Office Action Summary

10/816,097

JACKSON, JEFFREY

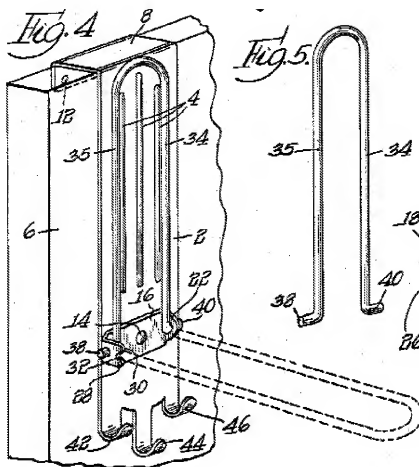
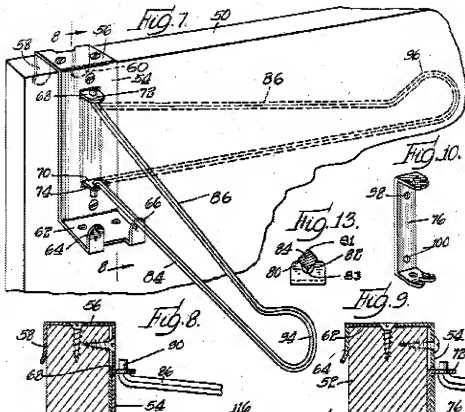
As to claim 13, wherein said holding portion has a shape that is capable of resting on a mantle. Note that the mantle shape is not defined and is not claimed. The

shape of the holding portion is clearly capable of resting on the mantle such as portion (8) can be resting on the mantle.

on Fig. 4 attached. Larson's projection 12 reads on as the friction element, which is affixed to said underside portion as claimed. Note that Larson's projection 12 presses into the wood to prevent inadvertent removal along not only a horizontal plane but also a vertical plane. This projection 12 is affixed to the underside portion of the holding portion and does a function which considers equivalent to a frictional element function as Applicant claimed. It should also be noted that Applicant's remarks with respect to Figures 7-9 for the limitation "frictional element" is not what Examiner indicated in the office action.
